Windmillhill Resource Recovery Project Transport Assessment Audit

Report for South Dublin County Council

July 2008

Document Type: Transport Audit Report

Figure 2.1 2009 (Construction Phase) AM Development Traffic Distributions⁴

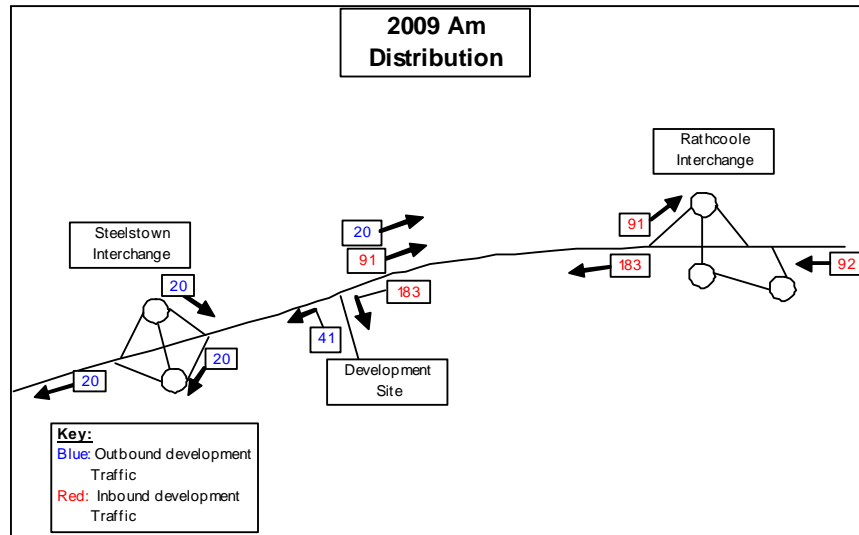
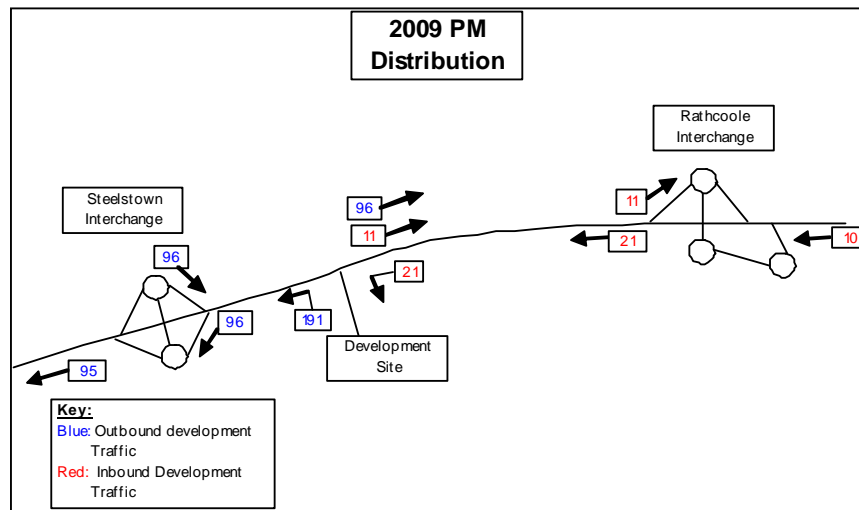
- 2.5.1 Figures 2.1 and 2.2 below show the distribution of development traffic on the N7 and Rathcoole and Steelstown interchanges in the 2009 (worst case) AM and PM peaks

2.5.2 As can be seen from the figures above an extra 91 trips pass through the Rathcoole Interchange and an extra 20 trips pass through the Steelstown interchange in the 2009 AM peak. When this distribution is applied to the horizon year (2026) of the N7RRP the amount of additional trips passing through the Rathcoole interchange in the AM peak will be 43 and the amount of trips passing through the Steelstown interchange will be 18. The Rathcoole Interchange will therefore experience a greater traffic loading in the AM Peak than the Steelstown Interchange, as the predominant direction of movement is to the site. In the PM

peak, the reverse is true, with Steelstown Interchange experiencing the greatest increase in traffic volumes, arising from traffic egressing the development, and using the Steelstown Interchange to turn northbound on the N7.

- 2.5.3 The above assessment assumed a 50:50 split for north-south access traffic, however it is likely that different distribution patterns would emerge in practice. This would require further catchment area analysis to determine whether the facility will have a local, county, regional or national catchment, and what are the implications for this in terms of the trip distribution patterns.
- 2.5.4 An alternative approach would be to analyse the impact of development related traffic, by applying varying distribution patterns (e.g. 67%:33%, 33%:67% for north-south trips) and analysing the impact of these different distribution patterns on the road network.
